ORDINANCE OF THE COMMON COUNCIL		
Approving a General Development Plan for Property located at the NE Corner of Williams Drive and Glacier Moraine Drive, Stoughton, Wisconsin		
Committee Action:	Plan Commission recommends Council approval 7 – 0	
Fiscal Impact:	Increased Tax Base	
File Number:	O - 12 - 2022	**Date Introduced:** April 26, 2022 **Re-Introduced:** May 10, 2022

Rezoning request for property located at the northeast corner of Williams Drive and Glacier Moraine Drive from Rural Holding to Planned Development – General Development Plan (GDP)

Re: Industrial Food Production and Storage Facility (Development)
Emmi-Roth USA (Applicant)

I have completed a review of the proposed PD-GDP - Planned Development – General Development Plan to develop approximately 20 acres for Emmi-Roth at the northeast corner of Williams Drive and Glacier Moraine Drive. A public hearing is scheduled for April 11, 2022 for the proposed rezoning. The following items are identified for your review.

CONCEPTUAL SITE PLAN

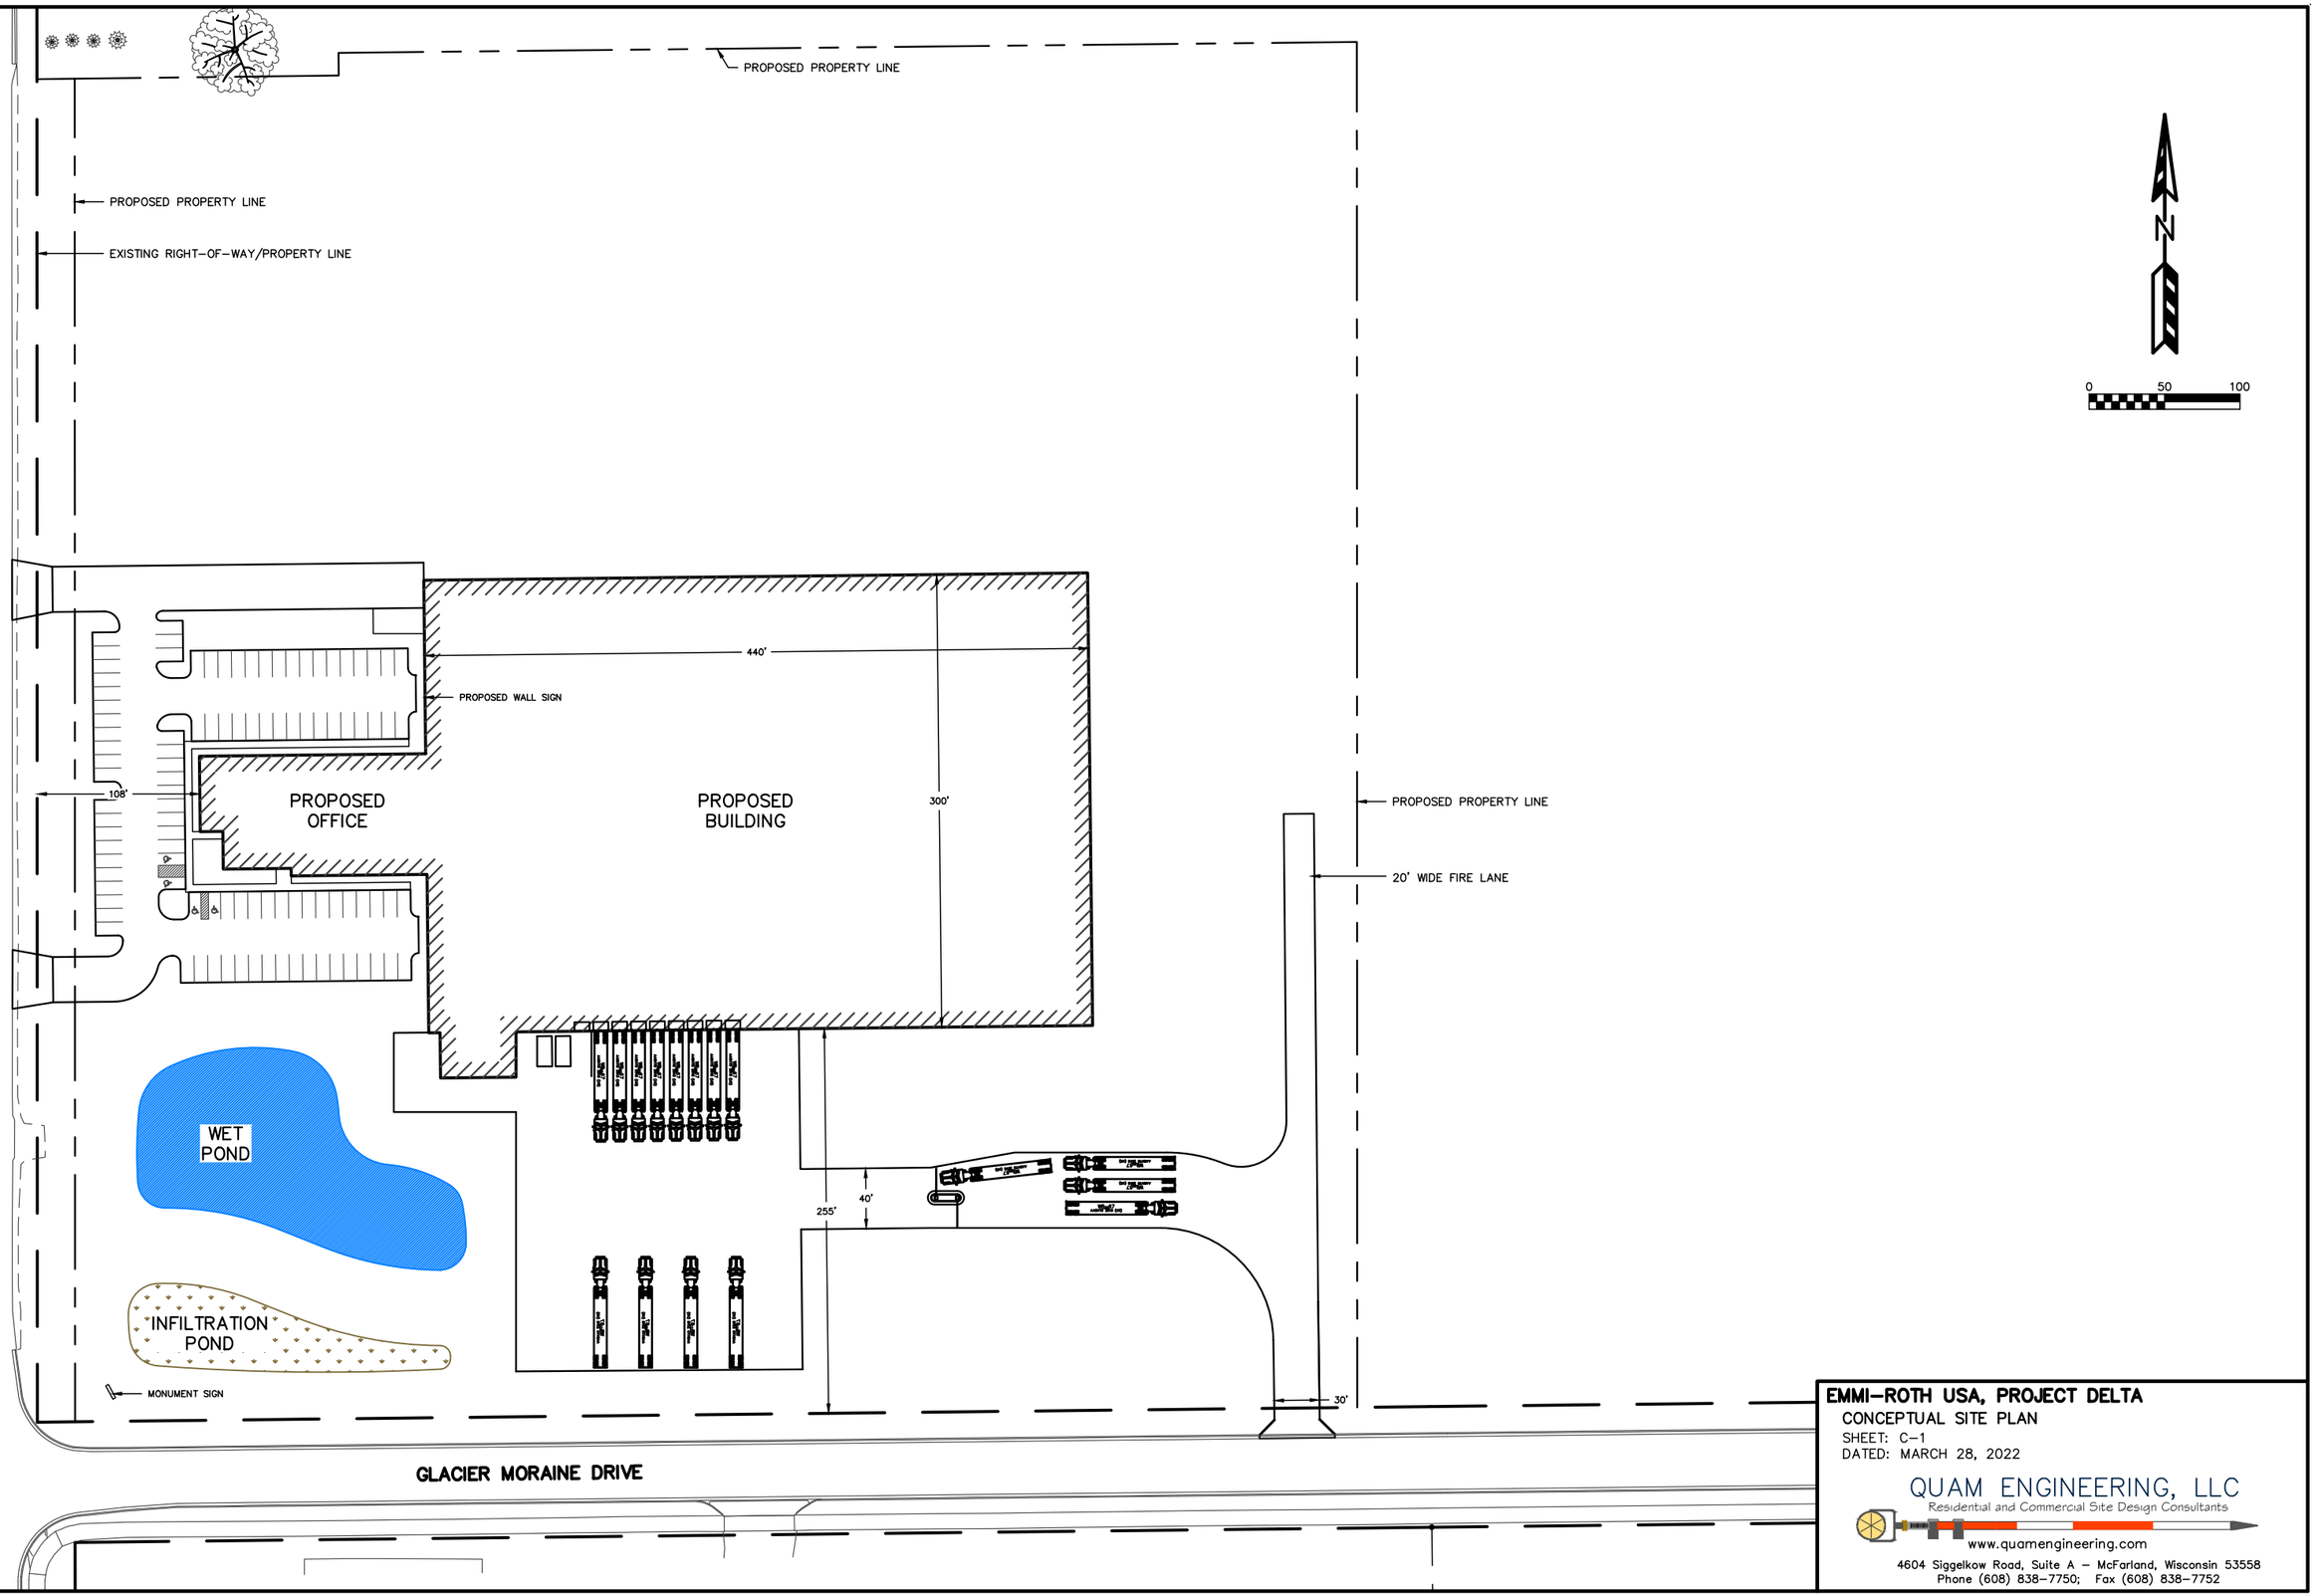
3. The plan should indicate the urbanization of the east side of Williams Drive. This should include addition of curb and gutter, storm sewer/inlets, asphalt path extension (10 feet wide), and fire hydrant adjustments if necessary. A 10 foot wide terrace is suggested between the curb and gutter and path.

4. All off-street parking areas designed to have head-in parking within six and one-half feet of any lot line shall provide a tire bumper or curb of adequate height and which is properly located to ensure that no part of any vehicle will project beyond the required setbacks. We suggest curb and gutter be used in parking lots and at key access points at a minimum. Curb and gutter will help control drainage, but will also better define hard surface areas and minimize disturbance of turf areas.

5. All driveways within the right-of-way shall be concrete.

6. Since there is a paved path on the south side of Glacier Moraine Drive, we are recommending no sidewalk along the north side of Glacier Moraine Drive however, a 5-foot wide, 6" think sidewalk section is still required through the access drive on Glacier Moraine Drive placed 6" out from the property line.

7. Curb ramps and path crossings of driveways shall be concrete.

8. Driveway widths shall be evaluated for truck turning movements. Code allows 30 feet of width at the property line and 35 feet at the curb. The Plan Commission has the ability to approve a wider with if necessary for truck turning movements.

9. Provide sidewalk connection between asphalt path along Williams Drive and building.

10. Signage, trees and any plantings at the access drives and at the Williams Drive and Glacier Moraine intersection shall meet all (10-foot) vision corner requirements.
